PLANNING AND ZONING COMMISSION MEMORANDUM

SUBJECT: SP2025-001; *Amended Site Plan for Advantage Storage*

The applicant, Brian Baca of ADV Rockwall John King Property Owner, LLC, is requesting the approval of an Amended Site Plan to update the landscape plan for a previously approved Mini Warehouse Facility [*i.e. Case No. SP2022-044*] and its subsequent amendment [*i.e. Case No. SP2022-062*]. The subject property is a 7.154-acre parcel of land (*i.e. Lot 1, Block 1, Cambridge Estates*), zoned Planned Development District 10 (PD-10) for Commercial (C) District land uses, and situated within the SH-205 Overlay (SH-205 OV) District and the SH-276 Overlay (SH- 276 OV) District. The subject property is generally located at the southeast corner of the intersection of John King Boulevard and Discovery Boulevard. On September 13, 2022, the Planning and Zoning Commission approved the original site plan [*i.e. Case No. SP2022-044*] for the construction of a *Mini-Warehouse Facility (i.e. Advantage Storage)* on the subject property. As part of this approval, the Planning and Zoning Commission approved variances to the building design standards that included: [1] a variance to the *Primary a

LANDSCAPE PLANTING PLAN

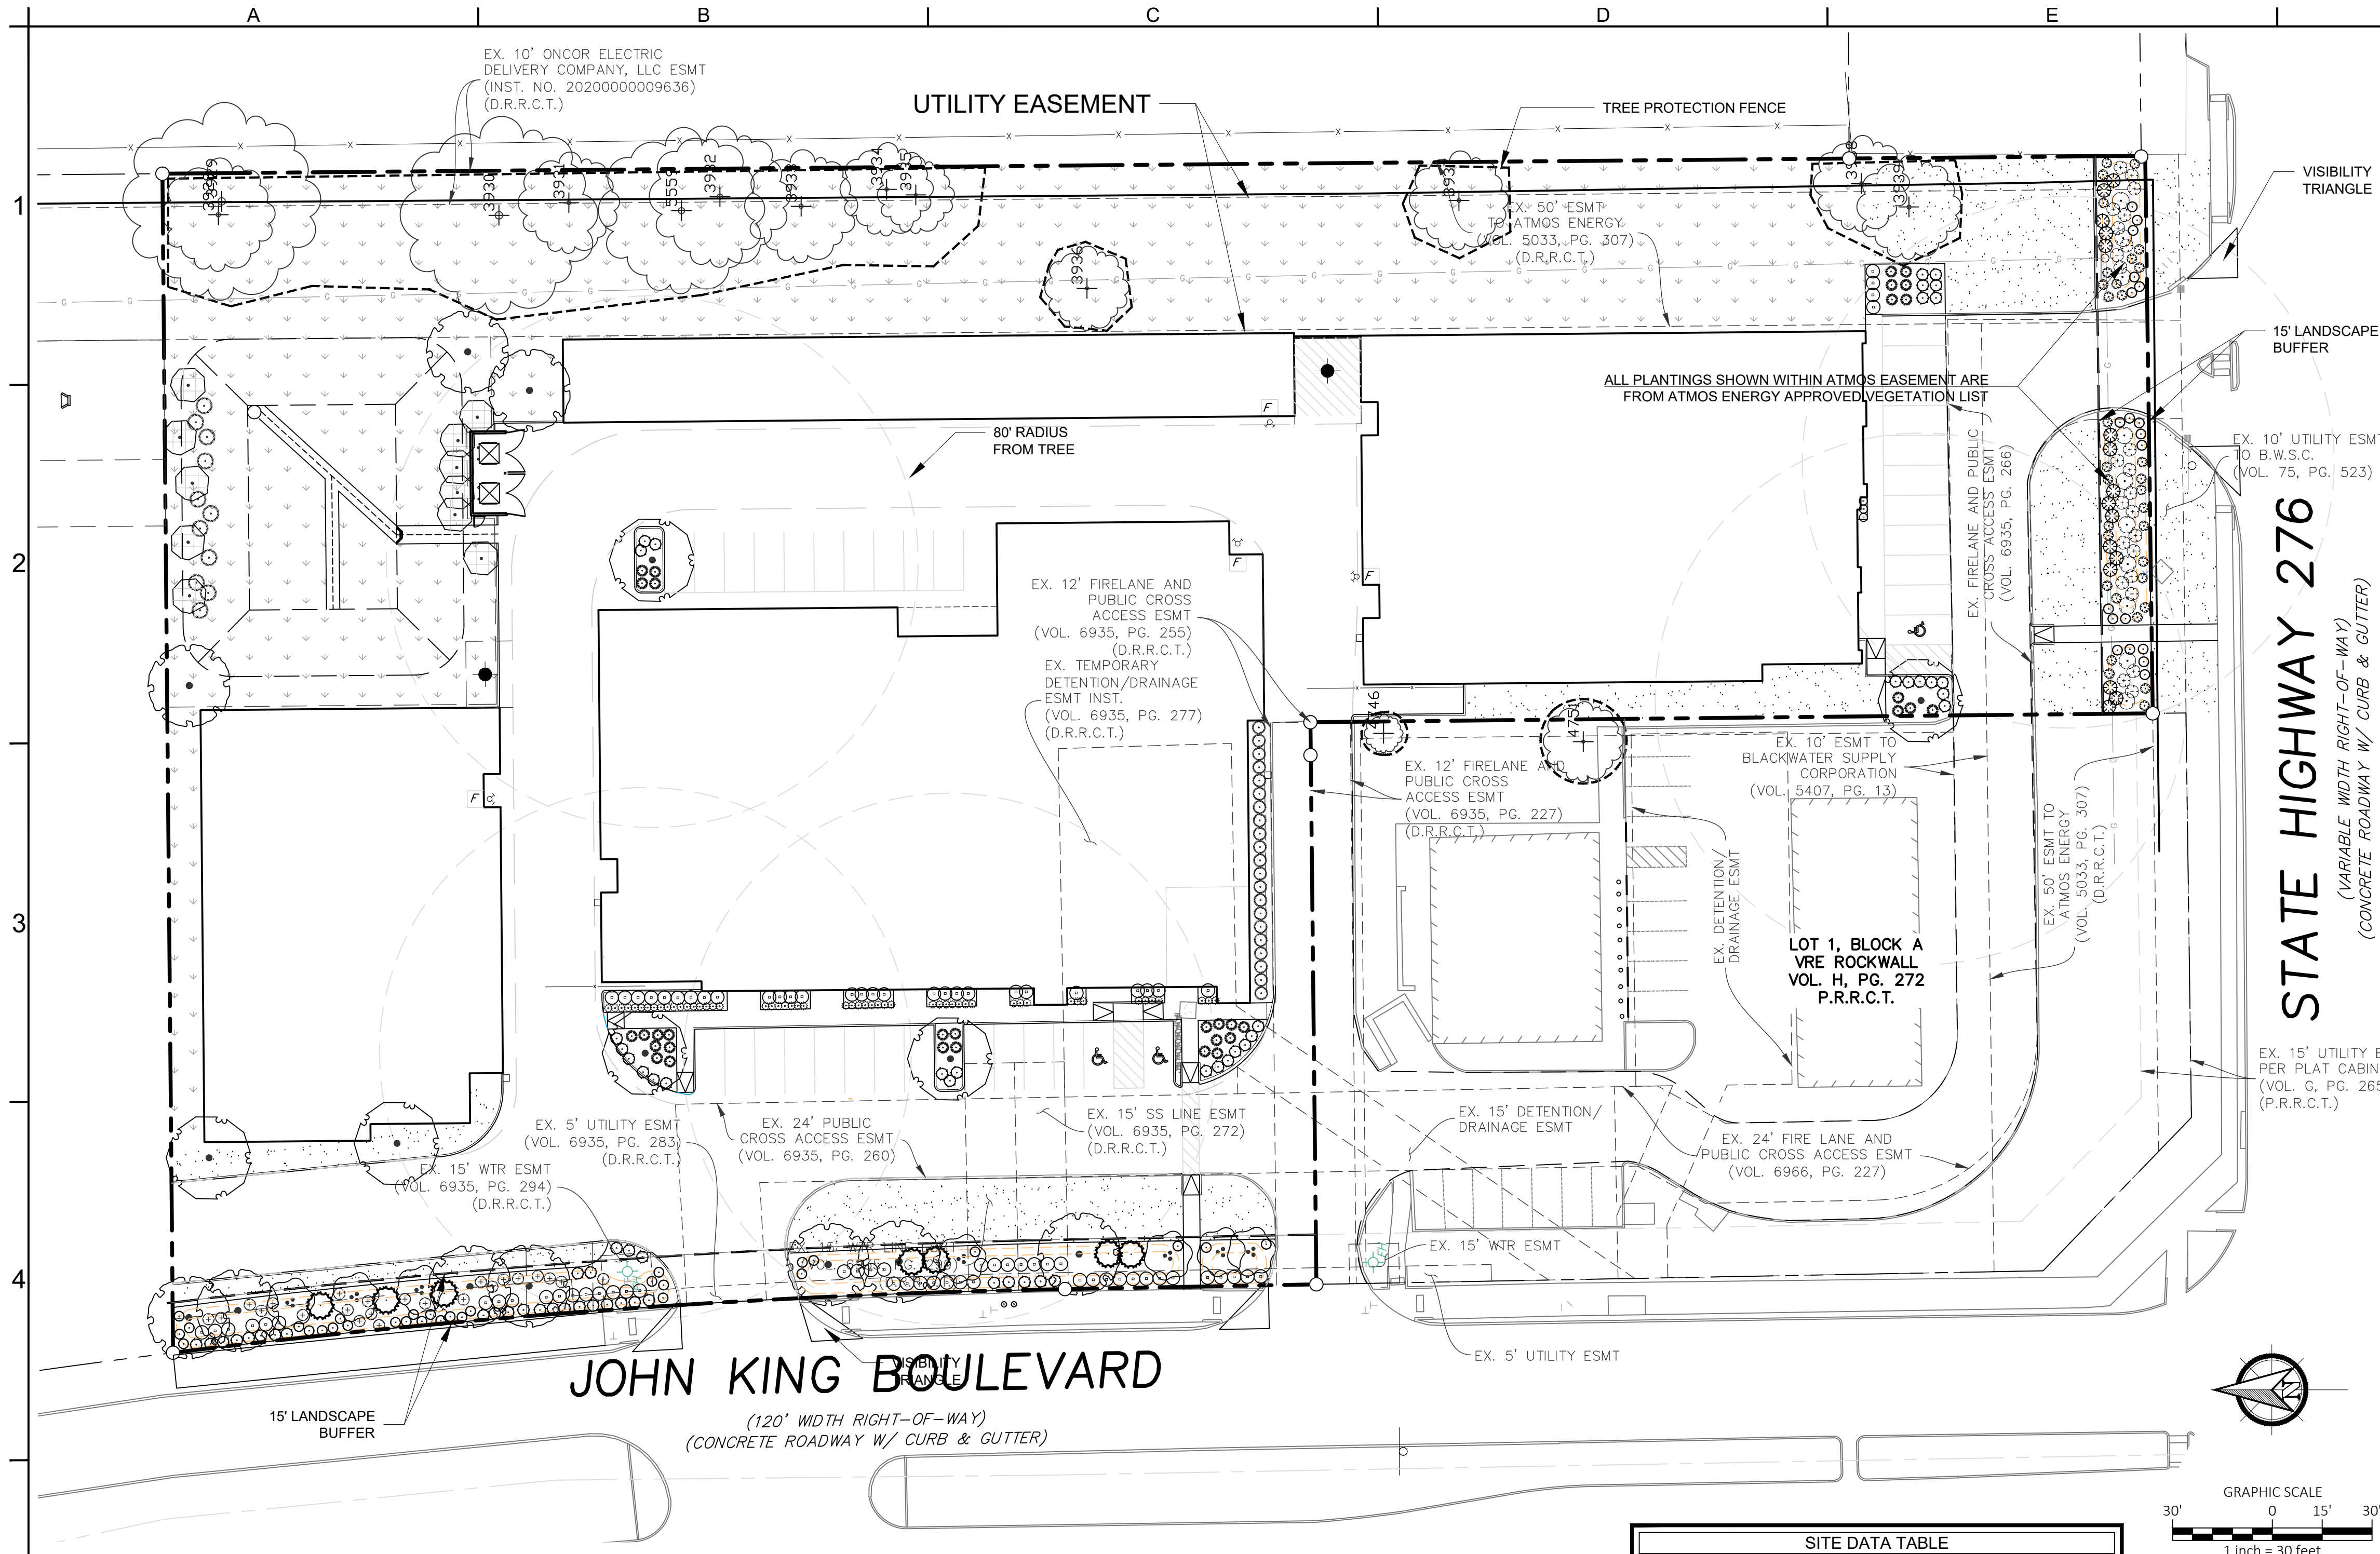
The updated landscape plan proposes small to mid-sized shrubbery and an 18"-24" undulating berm. According to Subsection 06.02(E)(1), of Article 05, of the *General Overlay District Development Standards* of the *Unified Development Code (UDC)*, "(a)ll landscape buffers shall incorporate ground cover, a built-up berm and shrubbery or a combination thereof along the entire length of the frontage. Berms and shrubbery shall each have a minimum height of 30-inches and a maximum height of 48- inches. In addition, two (2) canopy trees and four (4) accent trees shall be planted per 100-feet of linear frontage along the Primary Roadway..." In this case, the applicant is requesting a variance to these requirements along SH-276. Specifically, the applicant is [1] proposing a berm that does not meet the minimum requirements, [2] proposing to remove all canopy trees, and [3] proposing to remove all accent trees. Staff should note, that in the original Site Plan case, the applicant proposed compensatory measures to off-set the requested (*above mentioned*) variances. These included: [1] *additional shrubs along SH-276*, [2] additional shrubs along *Building A*, [3] additional shrubs along *Building D*, [4] additional shrubs along John King Boulevard, [5] using more than the required 20% stone on ten (10) out of the 16 facades focusing on the facades facing the public rights-of-way, [6] 16.80% over the required landscape area, [7] more than required canopy trees in the landscape buffer along John King Boulevard, [8] *more than the required canopy trees along SH-276*, [9] *more than the required accent trees along SH-276*, [10] extra trees along the detention area. As noted in the original Site Plan case memo, some of these compensatory measures were associated with requirements of the Overlay Districts and were not truly compensatory measures. In addition, based on the applicant's current request three (3) of these compensatory measures (*i.e. the ones underlined and italicized above*) would be going away with the current request. Staff should also note, that the Planning and Zoning Commission approved an amended site plan (*i.e. SP2022-062*) -- *as outlined above* -- for material changes to the building. As compensatory measures for this case, the applicant proposed: [1] *adding large shrubs along SH-276*, [2] adding shrubs along the front of *Building A*, and [3] *having 37% landscaping in lieu of the required 20%*. In this case the proposed request would change or remove two (2) of the three (3) compensatory measures associated with this case. With regard to the current case, the applicant is not proposing any

According to Subsection 09.01, *Exceptions to the General Standards*, of Article 11, *Development Applications and Review Procedures*, of the Unified Development Code (UDC), "...an applicant may request the Planning and Zoning Commission grant an exception to the provisions contained in the Unified Development Code (UDC), where unique or extraordinary conditions exist or where strict adherence to the technical requirements of the Unified Development Code (UDC) would create an undue hardship." In addition, the code requires that applicant provide compensatory measures that directly offset the requested exception. In this case, the applicant is not providing any compensatory measures to offset the requested variances to the *General Overlay District Standards* and is effectively removing five (5) of the previously provided compensatory measures with this request. Staff should also note, that the 50-foot Atmos easement was in existence prior to the applicant submitting the site plan, was depicted in the applicant's original site plan and landscape plan, and was not accounted for by the applicant in planning these landscape areas. With this being said, the applicant will need to make changes to accommodate Atmos' requirements; however, the applicant failed to account for the requirements with the original Site Plan, is removing items used to secure variances with the previous approvals, and is not proposing to provide any additional off-setting measures. Based on this, the applicant's request does not appear to be in conformance with the requirements of the Unified Development Code (UDC); however, variances to the *General Overlay District Standards* are a discretionary decision for the Planning and Zoning Commission and require a supermajority vote (*i.e. a three-fourths vote of those members present*), with a minimum of four (4) votes in the affirmative required for approval. Should the Planning and Zoning Commission have any questions concerning the applicant's request, staff and the applicant will be available at the January 28, 2025 Planning and Zoning Commission meeting.

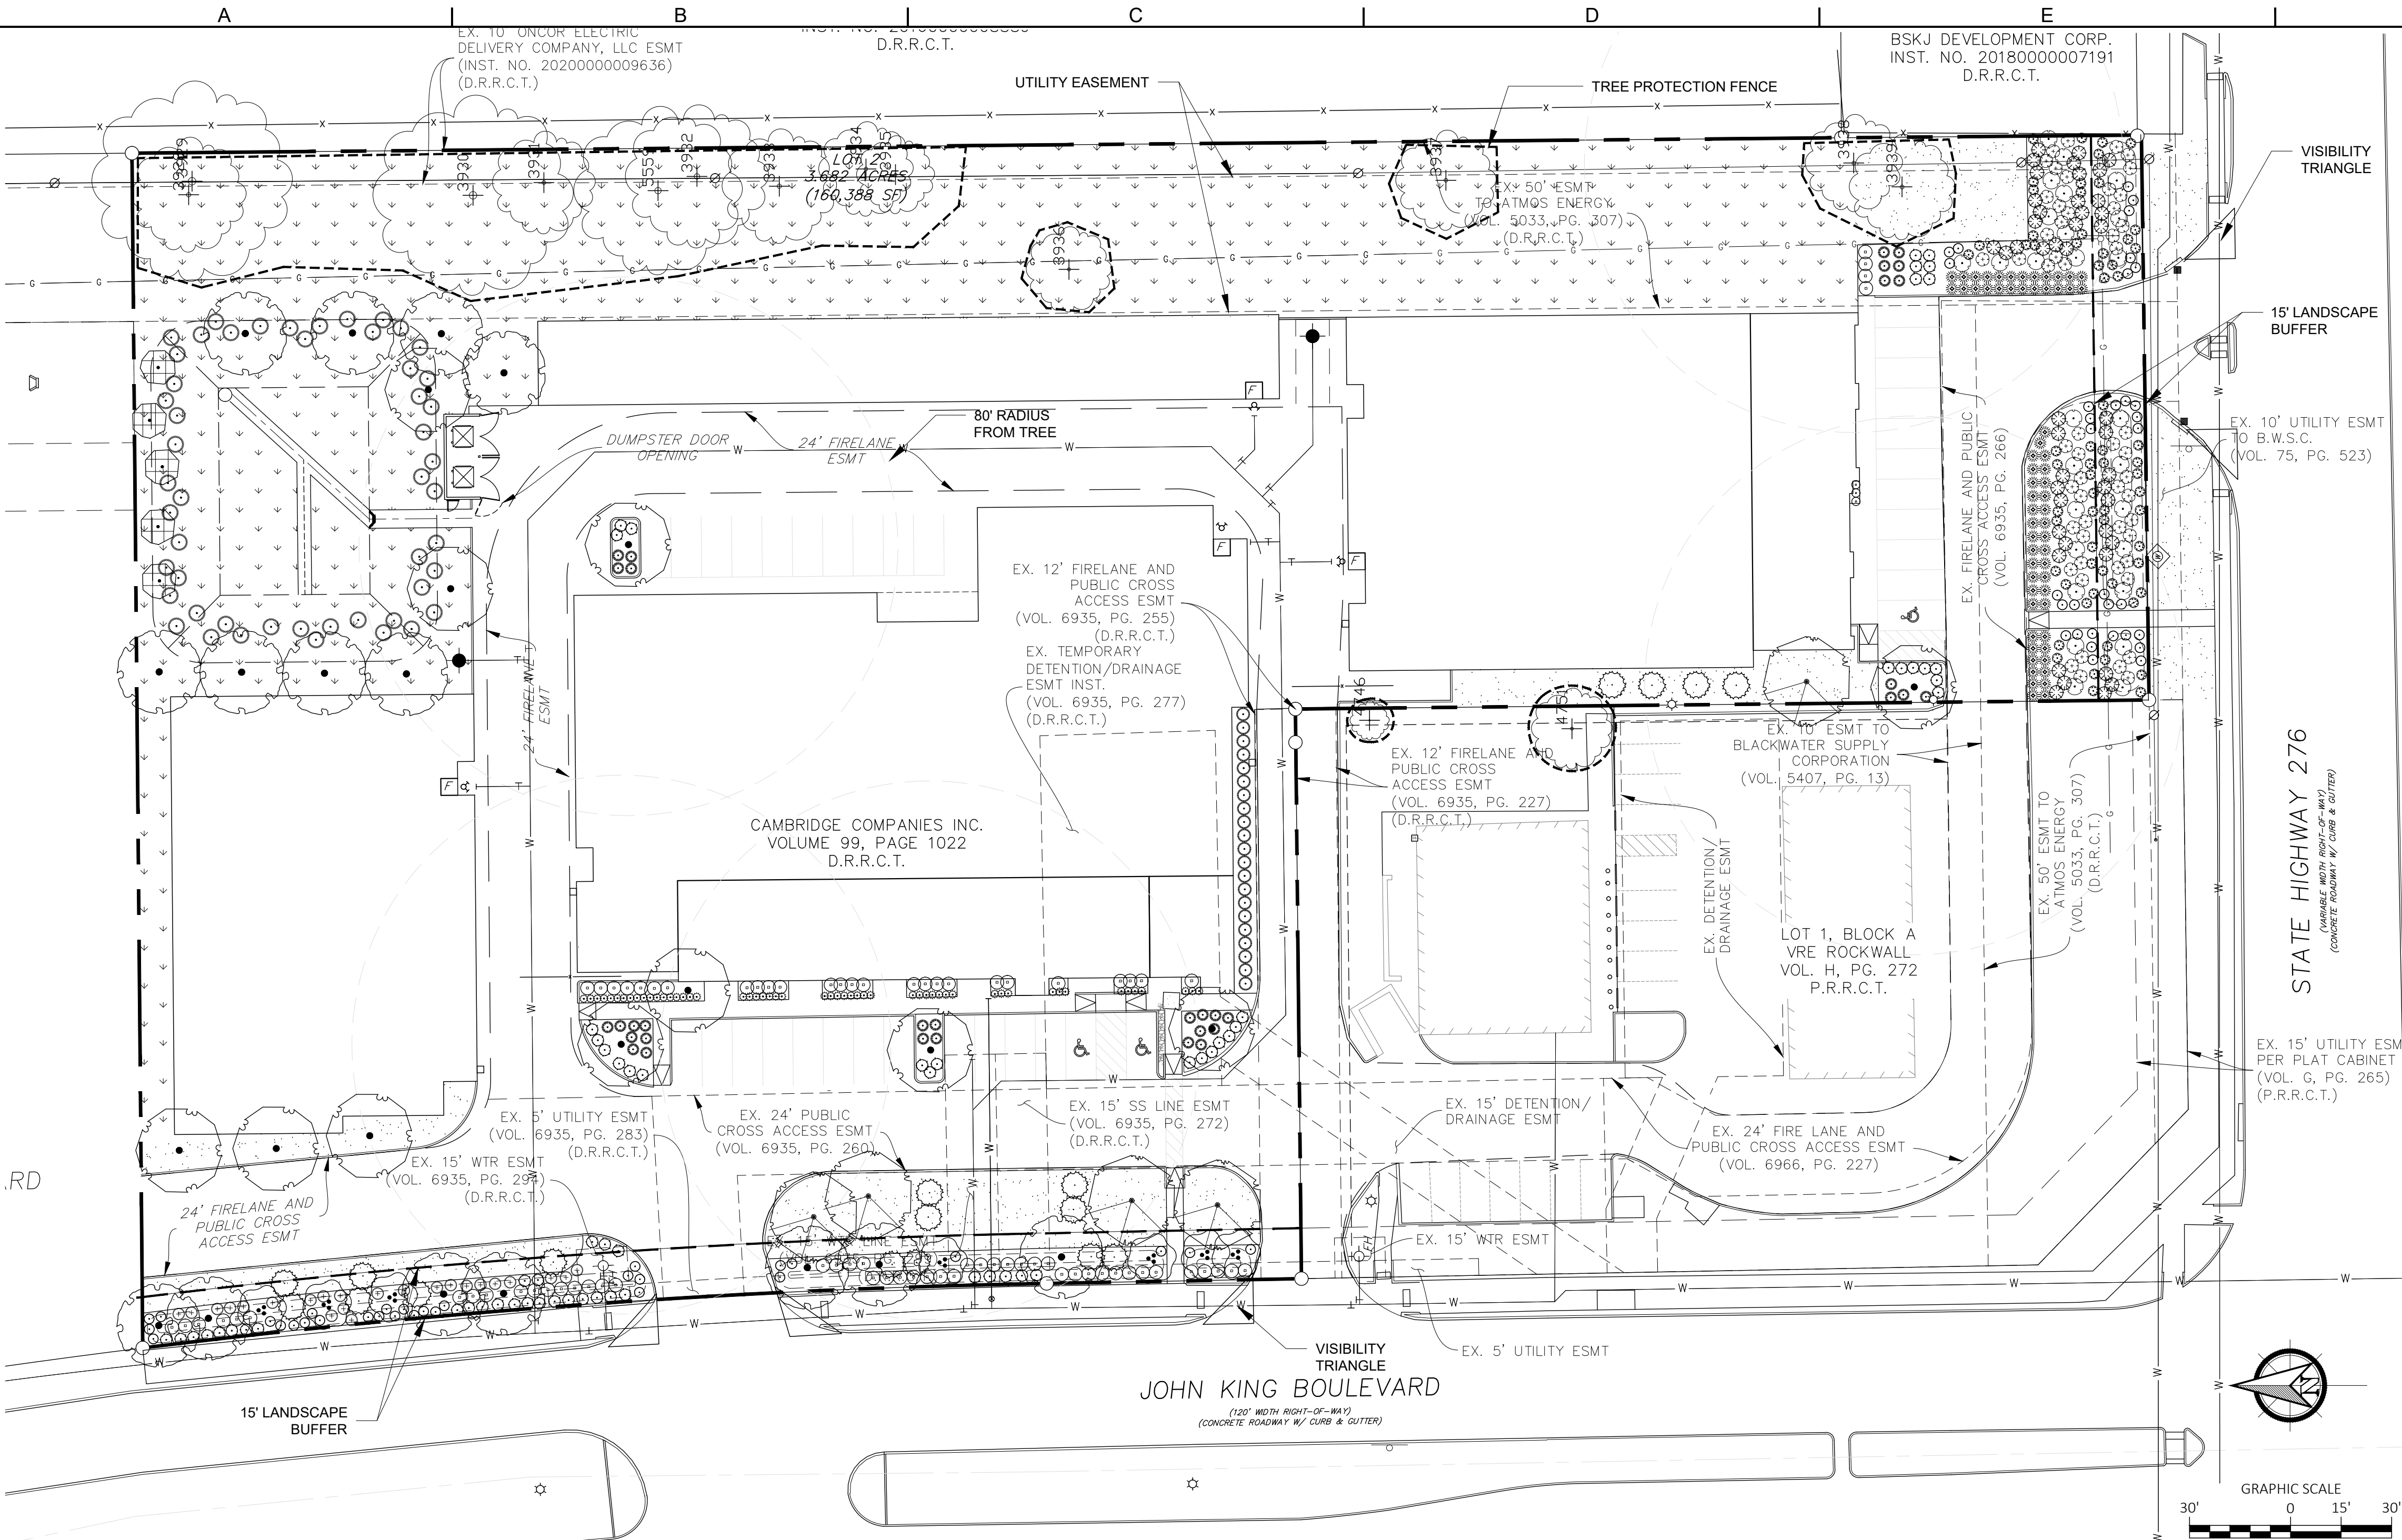
We sincerely hope that these accommodations and compensatory measures will make up for the oversight of large shrubs and shade trees being proposed and approved to be planted in a restricted area. We've continued to develop this property in good faith with the intent of presenting a beautiful facility and improvement to the community. These measures are intended to surpass the parkway beautification by landscaping that the City is promoting.

The attached revised LP-1 and LP-2, dated 2/03/25, reflect these changes.
